Planning Commission Regular Meeting

Tuesday, December 2, 2025, 5:30 PM

Planning Commission Staff Report – Work Session

Subject: Stouffer House Rehabilitation and Landmarking Work Session
(PL-2025-0342)

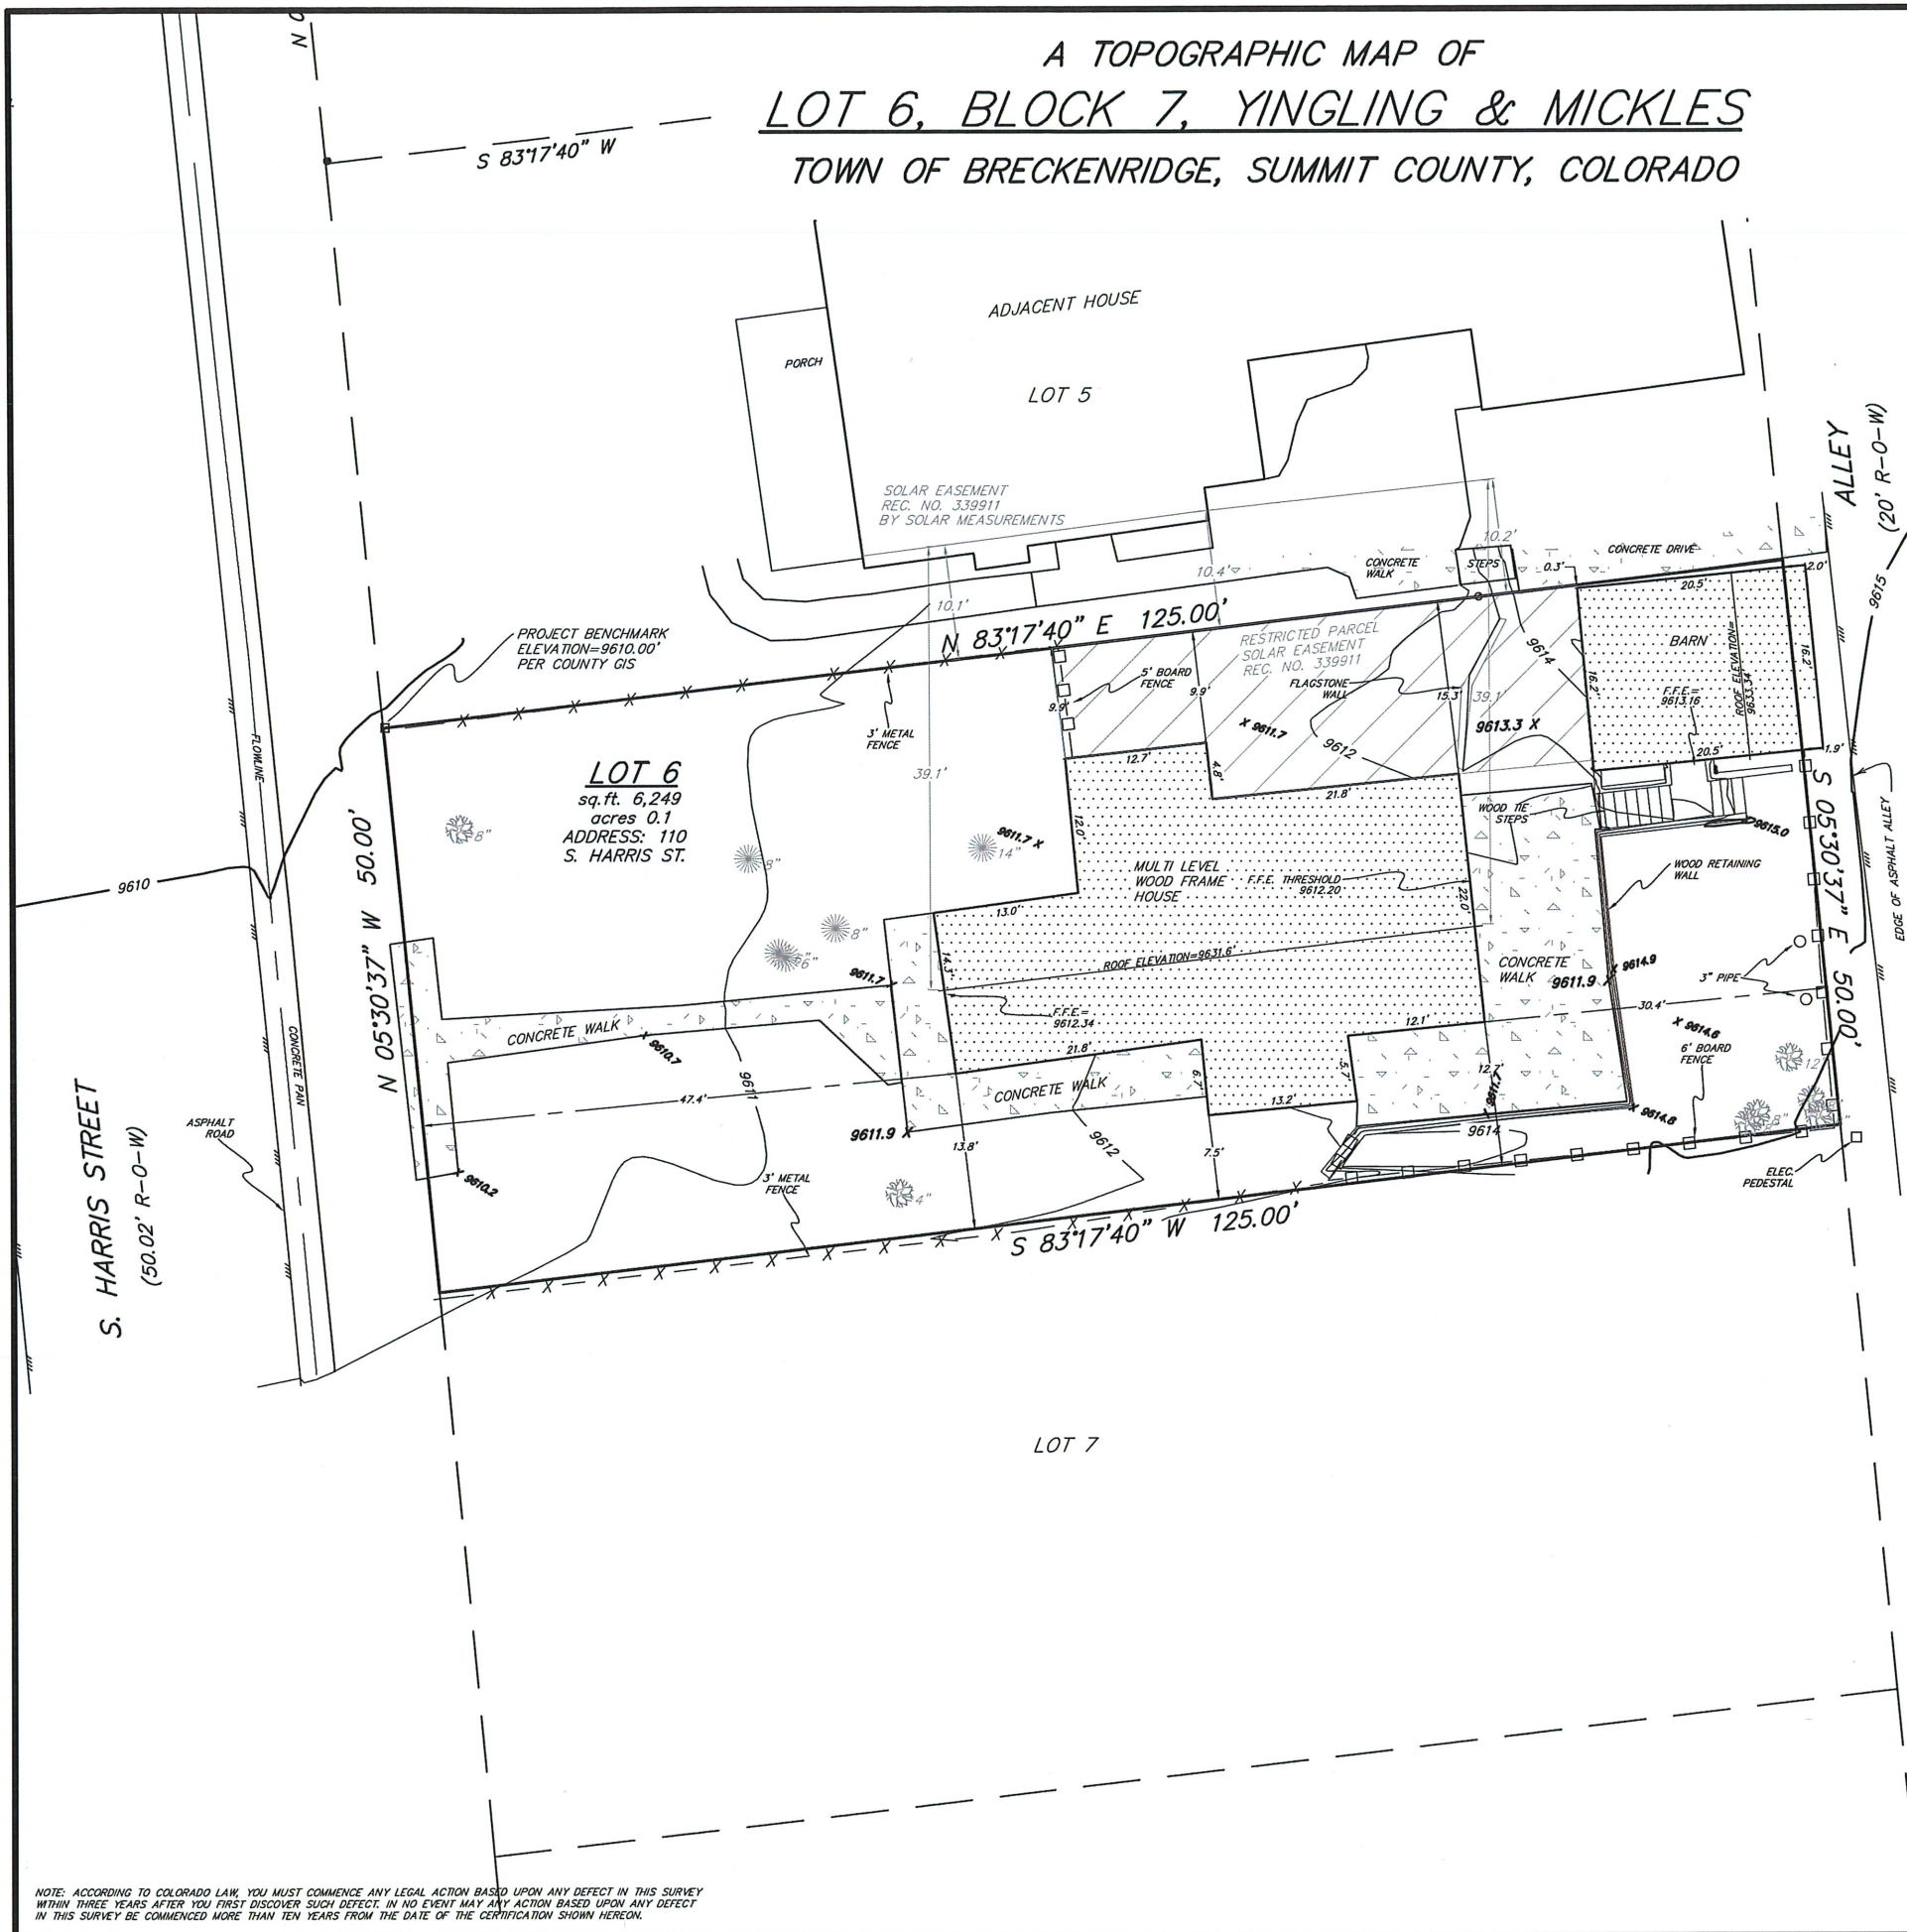
The applicant is proposing a new garage structure that contains an office/bonus room space on the upper level with a half bath to be used as a home office. There is not any proposed internal connection from the historic residence to the room above the garage. If this space is interpreted as a bedroom an additional parking space would be required.

The Town Development Code does not have a definition of “bedroom” but instead relies on the Building Code definition for “potential sleeping room.” Staff does not find that the space above the garage would be an ADU and the applicant is willing to sign a covenant that the space would not be used or rented as a short-term rental.

Additionally, staff does not find the space above the garage would meet the definition of “potential sleeping room” as the definition identifies a room or space within a ‘dwelling unit’. Relying on the Development Code Definition as well as the 2018 International Building Code, staff does not find the space above the garage meets the definitions. Staff finds the space above the garage is not a potential sleeping room.

Staff is requesting input from the Commission regarding the interpretation of the definition above and the correlation with the proposed space above the garage.

2. Does the Commission find the space above the garage to be a “bedroom” under the development code which would require a fourth parking space?
